# SERVICE BULLETIN

TR-9000

SUBJECT: TR-9000 TX PULSE NOISE IN SSB MODE

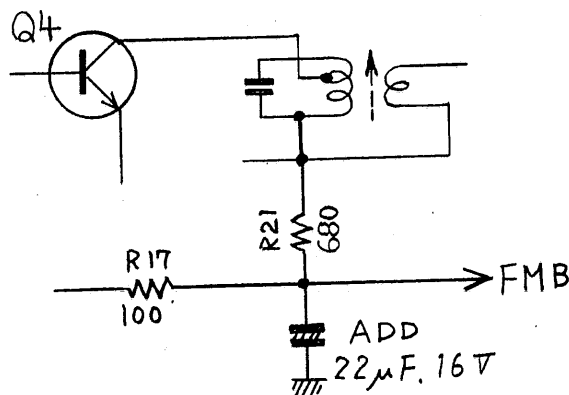
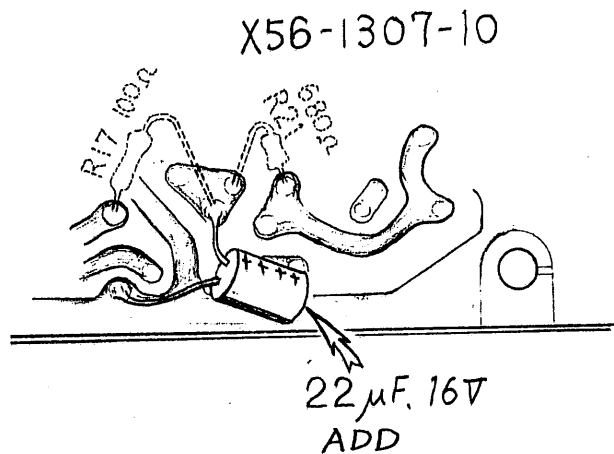
Pulse noise heard during SSB transmission may be reduced or eliminated by adding one capacitor to the TX unit.

On the TX unit X56-1307-10 add a 22 $\mu$ F 16V radial lead cap to the FMB line, as illustrated, on the foil side of the PCB. No adjustments are necessary.
